# Product Change Notification

**Change Notification #:** 119670-00

**Change Title:** Intel® Server System R1304WFTZSR,  
PCN 119670-00, Label, Product Design  
Power Supply (PSU) Label and Firmware Update

**Date of Publication:** September 08, 2023

### Label-Before

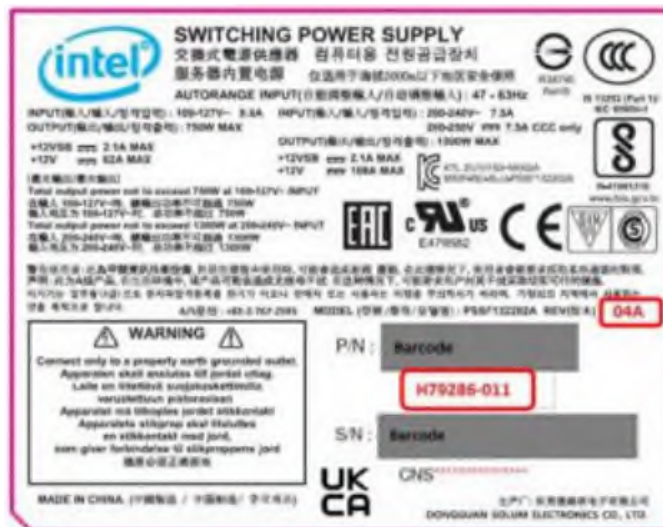
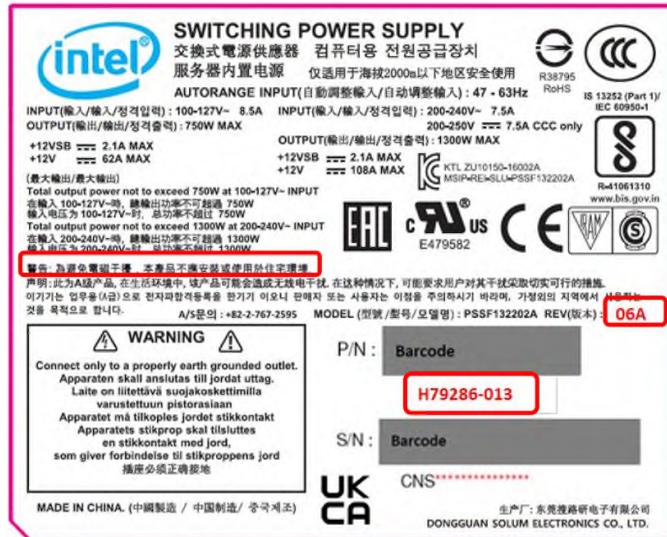
Addition of updated AXX1300TCRPS 1300W Power supply to the R1304WFTZSR SKU. The AXX1300TCRPS 1300W Power supply is changing from H79286-011 to H79286-013 due to a label update to incorporate the new Taiwan BSMI standards CNS15936 (CISPR32) and CNS15598-1 (IEC62368-1). The new BSMI standard has updated warning text that goes into effect January 1, 2024. Additional changes include a PSU firmware upgrade from 26.5.128 to 30.5.128 and a revision change from 04A to 06A. There is no impact to functionality.
